A G E N D A
FARRAGUT MUNICIPAL PLANNING COMMISSION

March 20, 2014
7:00 p.m. Farragut Town Hall

SUBJECT: Discussion and public hearing on a concept plan revision for the Bridgemore Subdivision, Tax Map 152, Parcel 25.01, 23.69 Acres, 41 Lots, Zoned R-1/OSR (Placemaker Development, Applicant)

SUBJECT: Discussion and public hearing on a concept plan revision for the Cottages at Pryse Farm, 30.81 Acres, 55 Lots, Zoned R-1/OSMR (Wilcox Development, Applicant)

PLAN VIEW
PROPOSED LOT LAYOUT

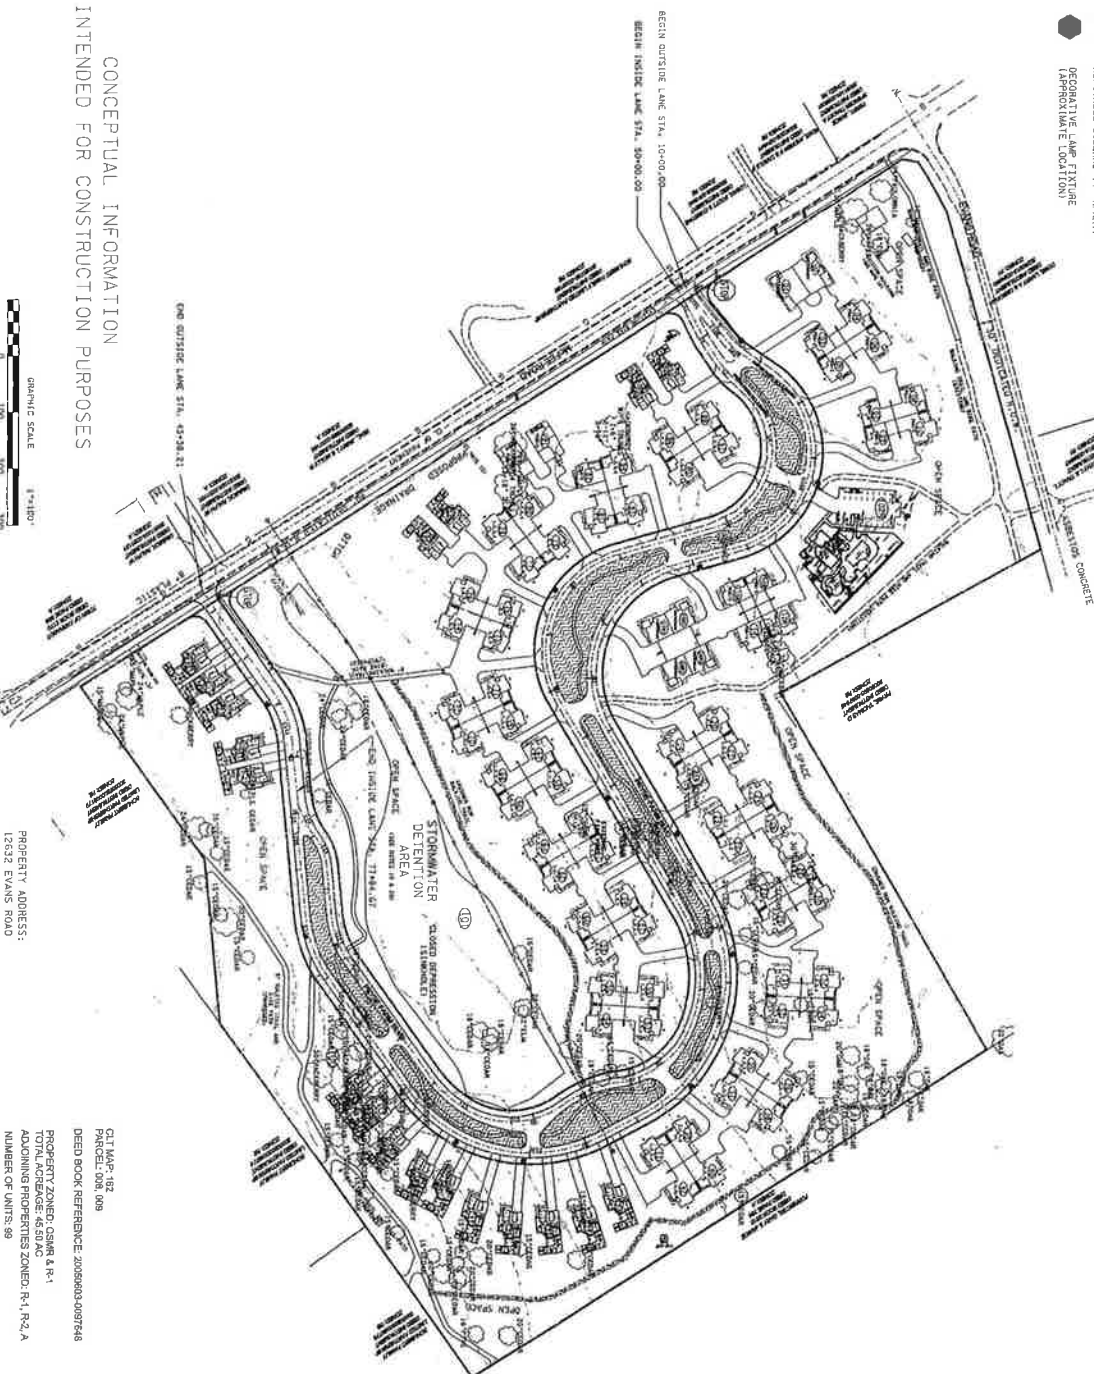
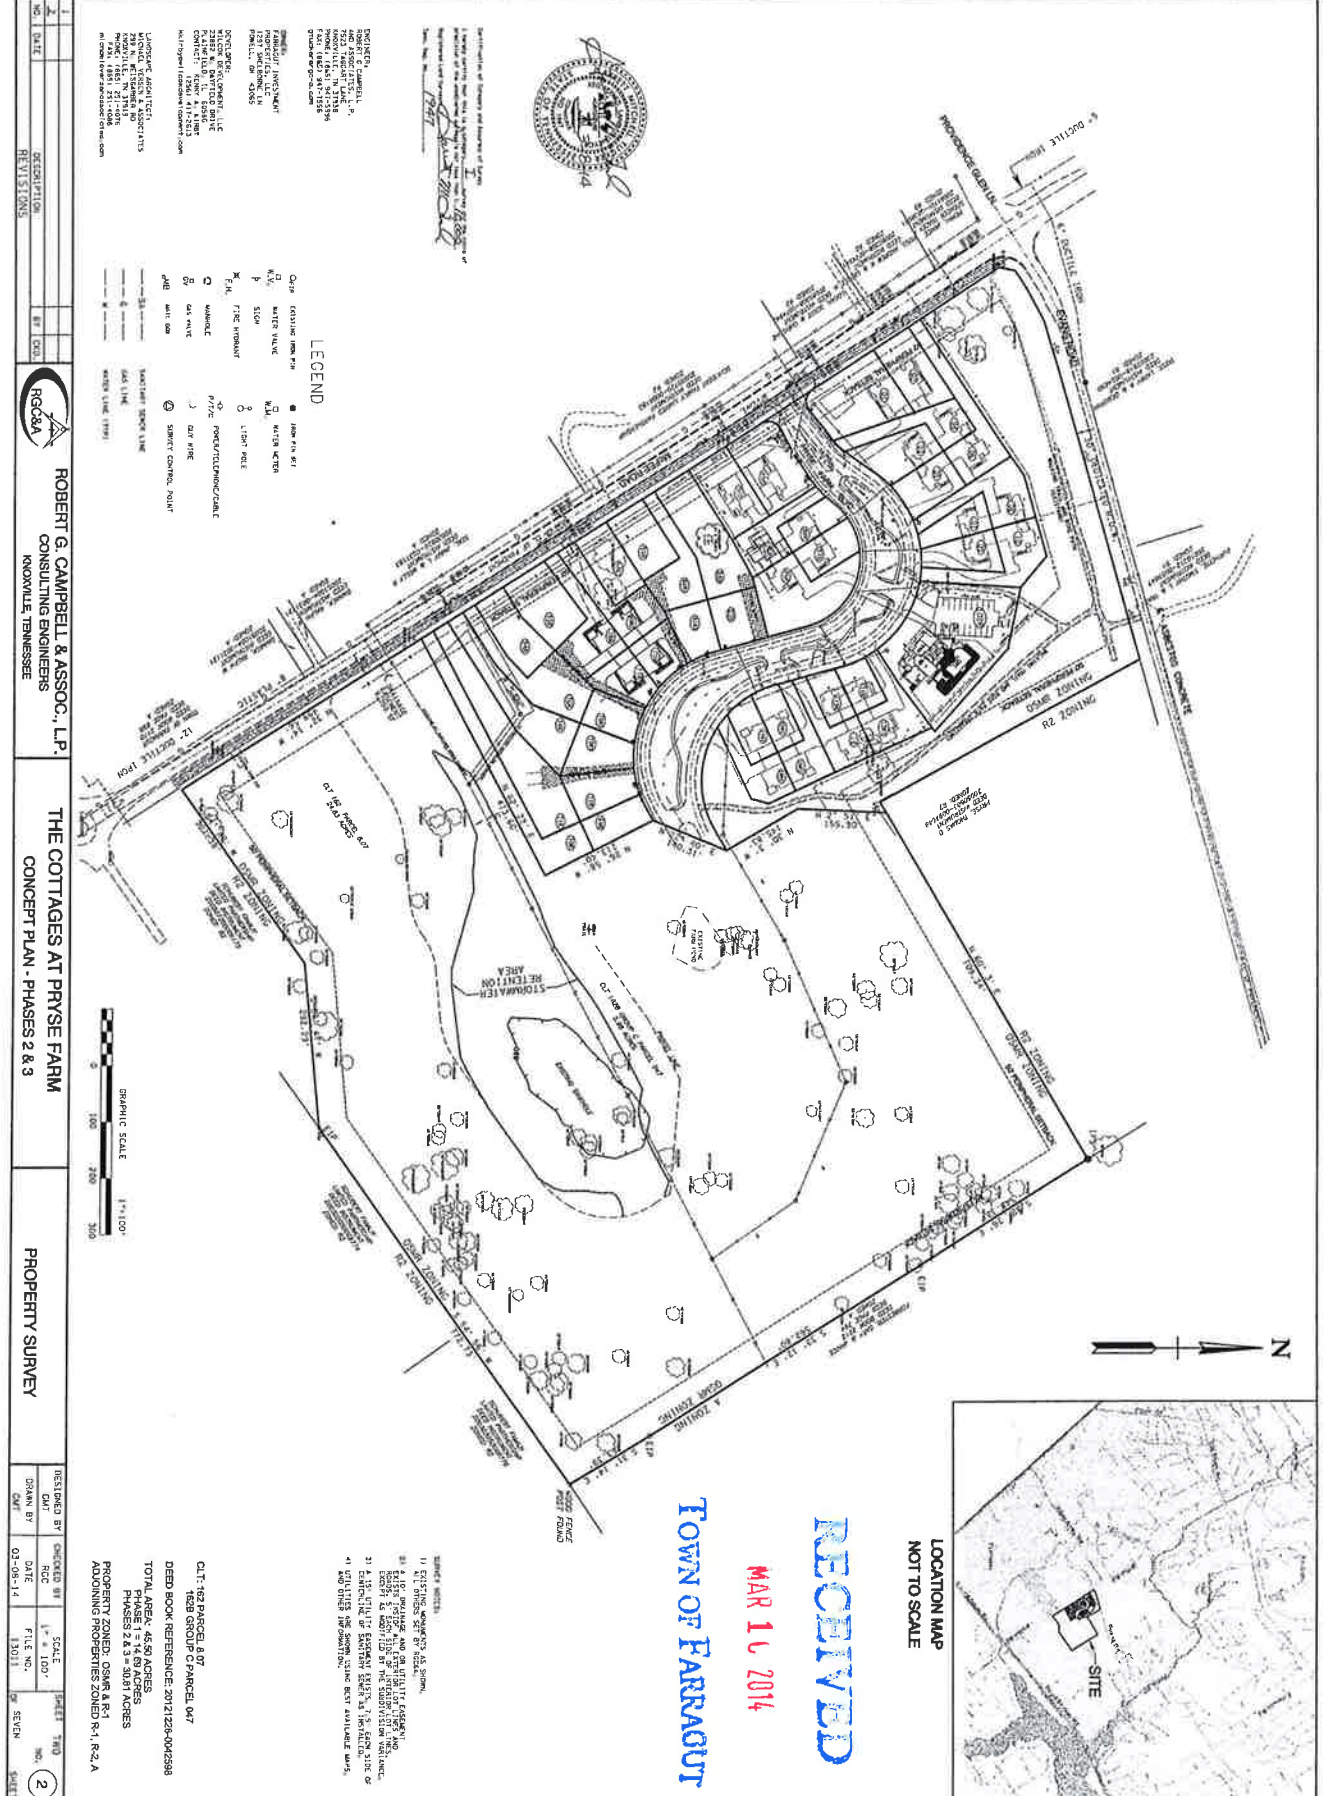
- 1) Maintains 99 dwelling units but increases the proportion of units that are single-family detached. The total open space is slightly increased from 18.28 acres to 18.31 acres;
- 2) Adjusts the roadway alignment south of the major drainage area so that the road is shifted to the south in order to provide for a lot layout that works better with the topography. The layout would also provide residents with a private back yard that faces permanent open space;

- 3) The rain gardens have been modified so that they gradually transition out of the boulevard and are situated to the sides of the road. The concept plan maintains the flat curbing that has been used in the built out portions of the Cottages and drains water to the rain gardens; and
- 4) The walking trail system has been re-designed to try to follow contour lines. The proposed 8 foot wide walking trail system associated with this concept plan is requested in lieu of concrete sidewalks that have been constructed within the rain garden areas in the built out portion of the development. Based on feedback from the residents, the sidewalks within the rain gardens receive less use because of slopes on the sides of portions of the sidewalks. The sidewalks also create maintenance issues due to their configurations within the rain gardens.

- 1) The staff is supportive of the proposed modifications that would include more single-family detached units. This change, however, must be presented to all of the existing homeowners and be approved by at least 75% of the homeowners. The applicant is aware of this stipulation;

- 2) The staff is supportive of the requested road alignment modification with the exception of perhaps a couple of areas within the boulevard being adjusted to include a rain garden. This would help provide more visual consistency throughout the project;

- 3) Related to the previous comment, the staff is supportive of some of the rain garden areas being to the sides of the roadway but would encourage, for visual reasons, some portions of the rain gardens to be contained within the boulevard. The staff will also recommend that the rain gardens be planted in a manner that is consistent with the existing portions of the development. A landscape plan will be required for these areas; and

- 4) Though walking trail alignments will still need to be field verified with the Town staff, the general walking trail system proposed would seem to be more inviting while at the same time require less maintenance. The planning commission has the authority (and responsibility) to establish the appropriate pedestrian facilities associated with a development where such facilities are required. The planning commission can approve, in lieu of a sidewalk, a comparable alternative and, in this case, given the scale of the walking trail system proposed, the staff would recommend acceptance of this requested alternative.
